MEMORANDUM

TO: City Planning Commission, Committee of the Whole
FROM: Shanna Sether, Senior City Planner, (612) 673-2307
DATE: June 30, 2016
SUBJECT: White Castle, 600 Central Ave NE (proposed address)

SHEET TITLE
STORM SEWER PLAN
SP3

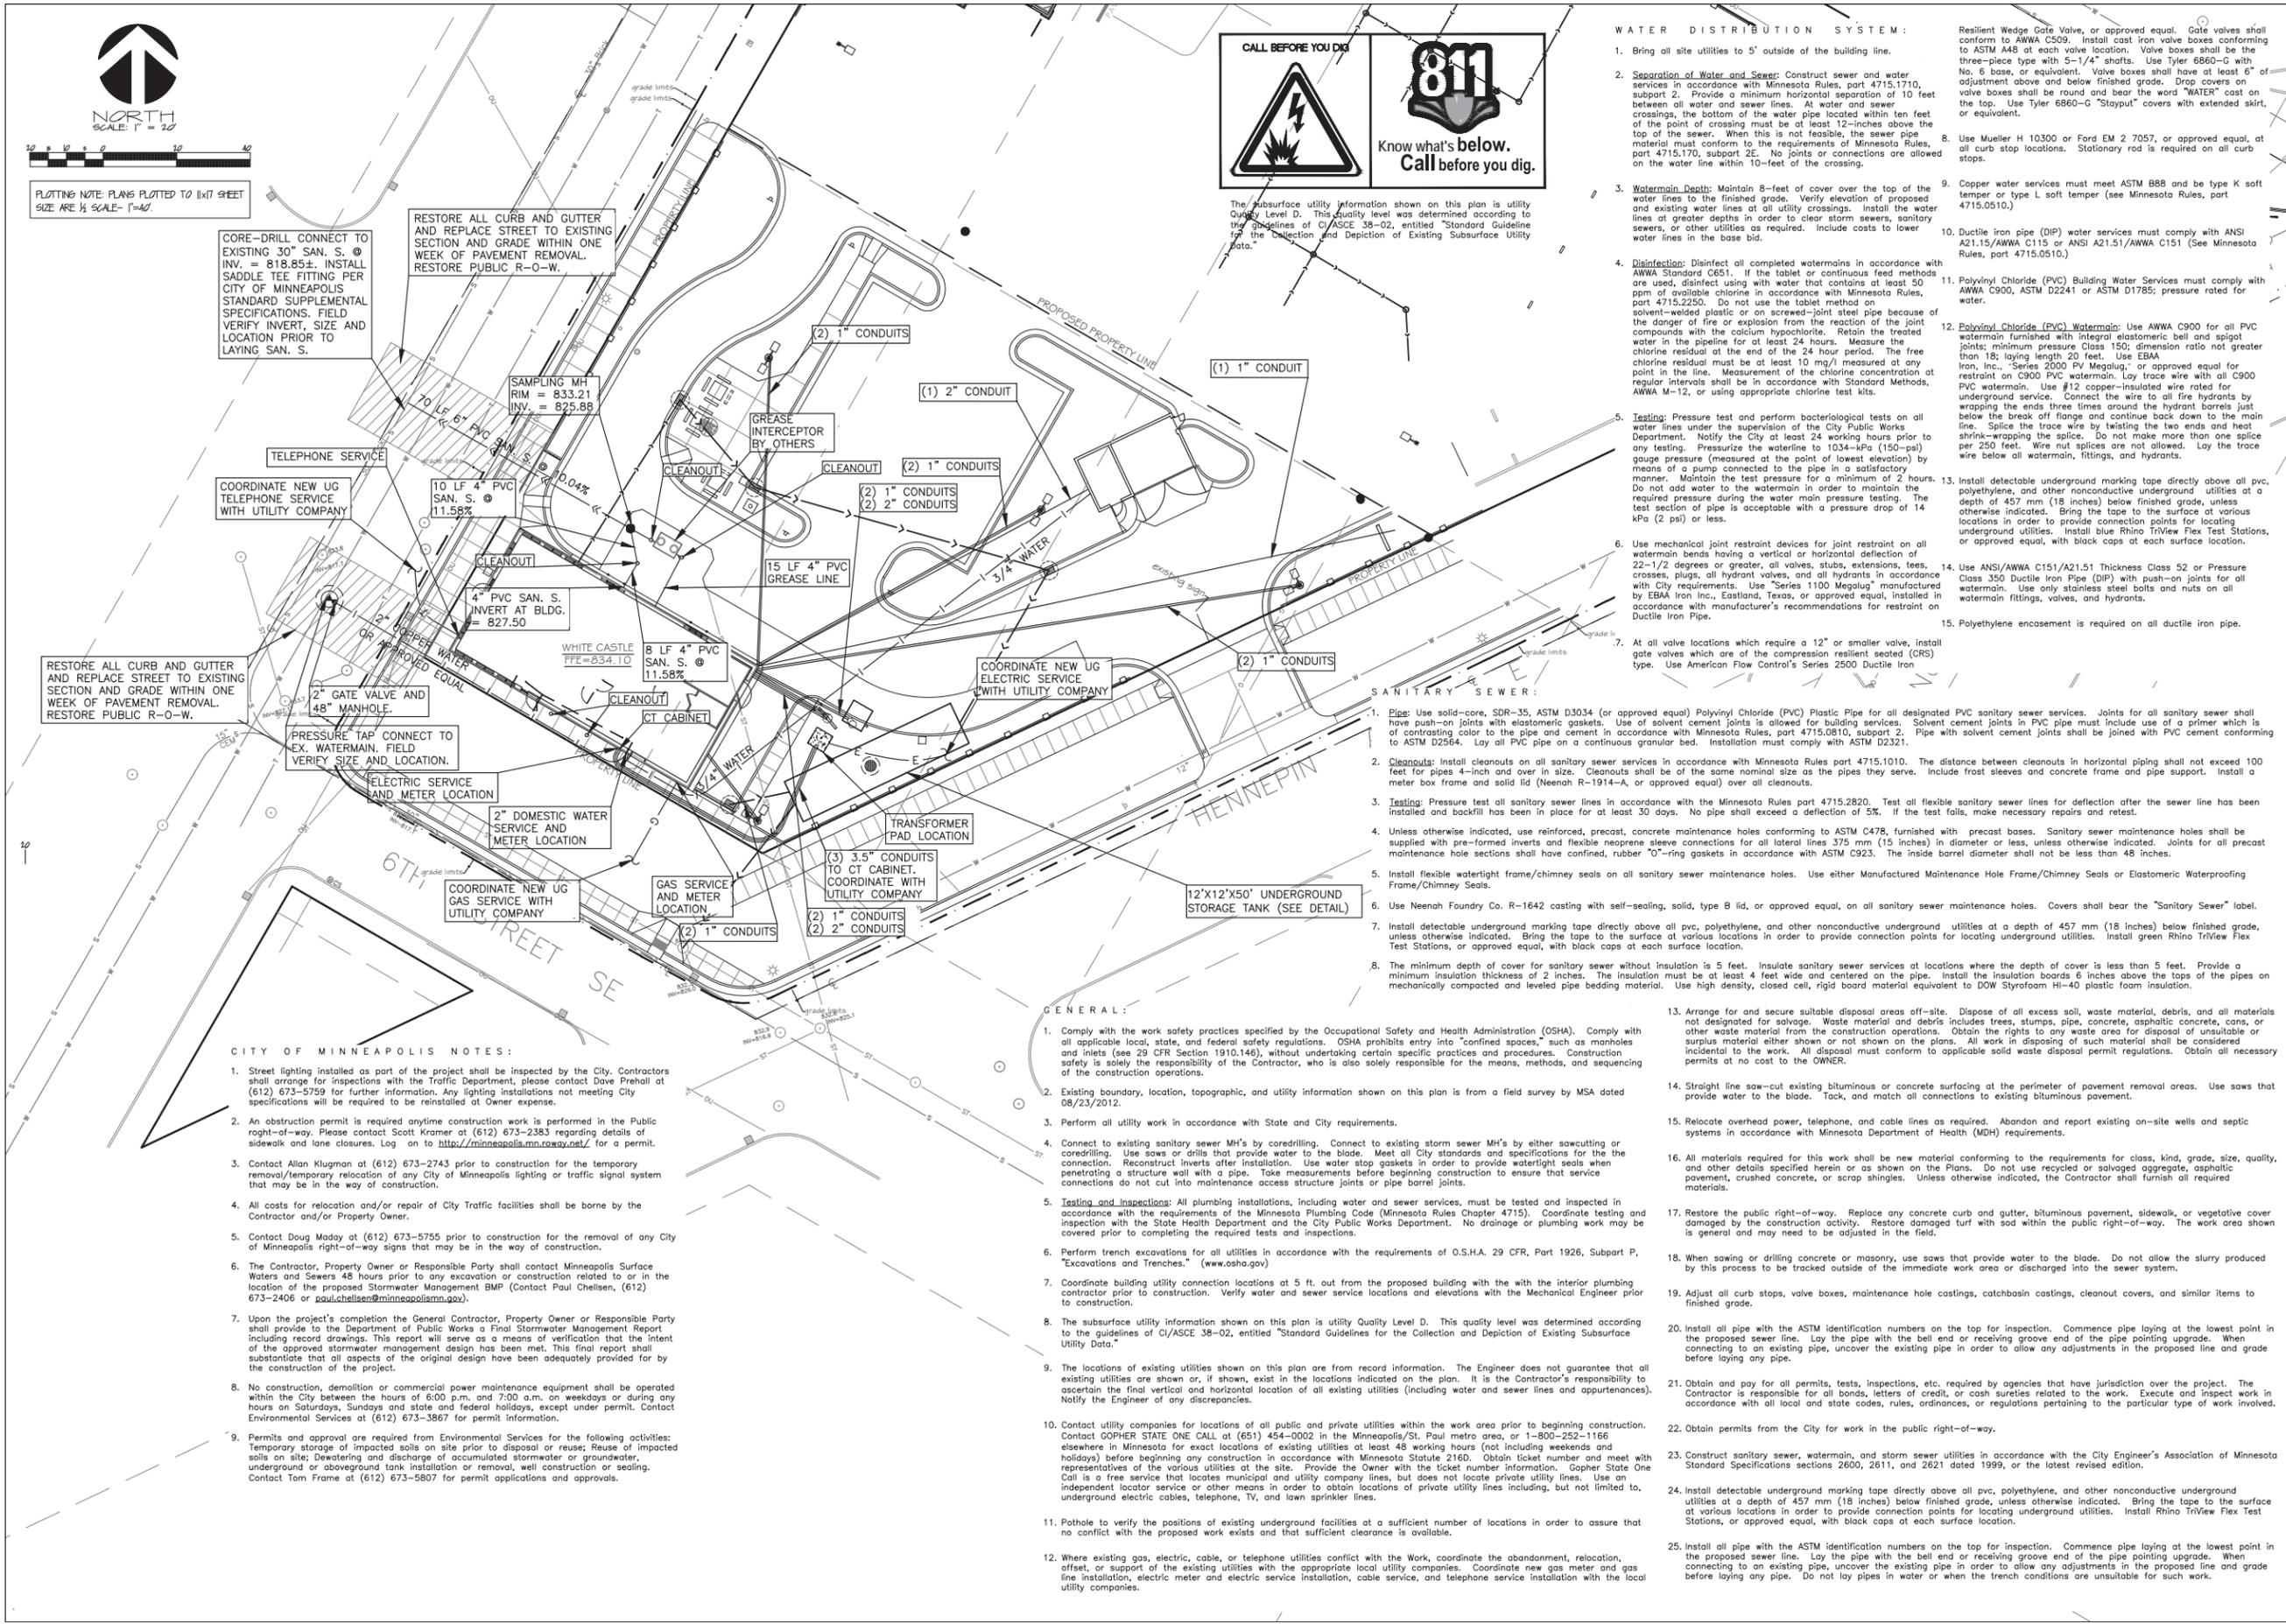
- Surface Drainage: Please indicate how the right-of-way between 6th St SE and the property line will be graded and finished.
- Utility Connections: The City storm sewer manhole proposed to be connected into with a storm sewer service is identified on Sheet SP3 as a "30" storm s. catch basin." The existing structure does not appear to be a catch basin, but a manhole. Please verify. A private connection to a City catch basin would not be permitted.
